Objection to the Uniting Kingscliff Redevelopment (SSD-47105958)

I object due to the following

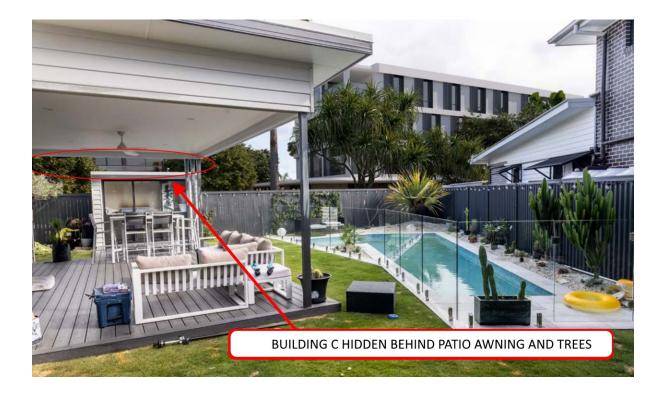
Privacy is of utmost concern, for as our house backs right on to the RAC building (pictured) immediately there are 36 Rooms that can see into our backyard. Not only that but as Uniting has applied for a four-storey project this has pushed the carparking to maximum capacity and as a result high and tall trees that are required on site have to be grown on mounds (or small hills) up to 1200 in height.

Moundings appear in the aqua coloured dotted line. This means that as our fences are 1800 high an adult or a small child can stand on top of these mounds and see straight into our yard. Then there are all the workers during construction that can also see into our property, and I am concerned for I am also concerned for my little sister who is somewhat shy and she is only 11 now but what will happen when she is in her teenage years and she and in the pool with her friends of a weekend or doing cartwheels on the lawn and then one of the workers in the building makes a rude comment. She will never go back in the pool, and probably not even into the backyard ever. My bedroom is on the top floor and as I have a north-western aspect I will be surrounded by buildings; Building C to the south, RAC to the west and Building F to the north. It will be like living in an apartment in the city for there are no other 4 storey buildings in this area, and all of a sudden over my back fence there are three massive, four storey buildings.

Cross sections and sight lines must be supplied by Uniting for it is unknown how much sun I will lose in my house at what particular time of day. What time will I lose sun in my dining room? Will I have sun on my patio when I have breakfast at 9am? What time of an afternoon will we be in total shade? What time will we lose sun in the pool? I don't know and I should know and in the DA there should be a document that explains the amount of loss of sun inside our house but every other house that is affected
